Product Change Notification / RMES-21CWWT073

CCB 4629 Final Notice: Qualification of STA as an additional assembly site for LAN7500x, LAN8820x and LAN9730x device families available in 56L VQFN (8x8x0.9mm) package.

**CCB 4629**  
**Pre and Post Change Summary**  
**PCN#: RMES-21CWWT073**

## ASE

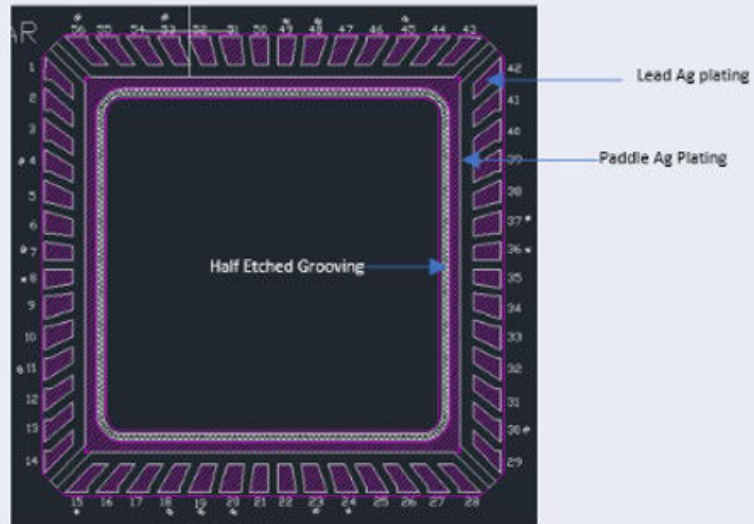
### LF Definition – Double Ring Plating

\*Plating on Lead finger and plating surrounding LF Paddle (Purple shaded area)

Lead frame Paddle size	240 x 240 mils
------------------------	----------------

## STA

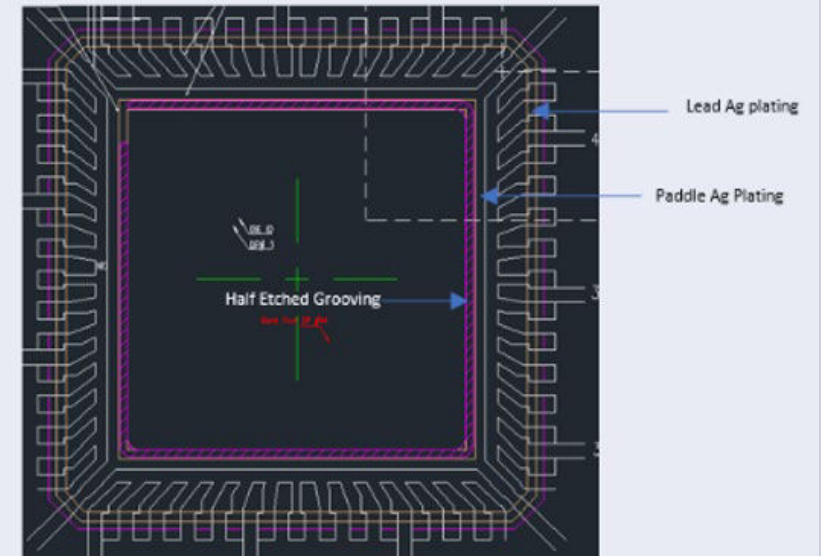
### LF Definition – Double Ring Plating

\*Plating on Lead finger and plating surrounding LF Paddle (Yellow outline area)

Lead frame Paddle size	236 x 236 mils
------------------------	----------------
